21097 Greenwood Leflore Consolidated SD ESSER / Report Number 004

Contract Upchurch Plumbing, Inc.

Fixture Install

Figure 3 – This does not look like it meets our minimums; check A-401d/8 for conformance

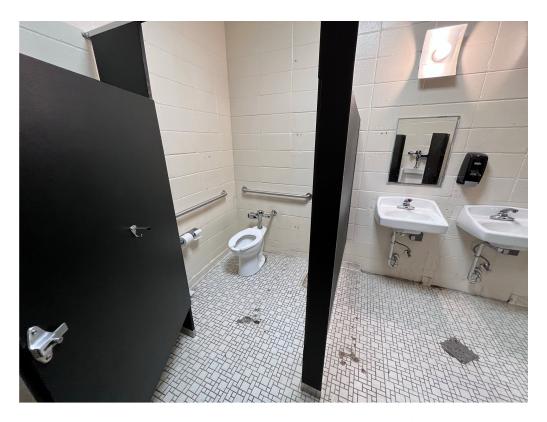
and school was still in session. A security guard showed me around to review work. All work appears to be in good order, except one toilet room that includes an ADA toilet which does not appear to meet our minimums. Please look into figure 3's conformance to the documents.
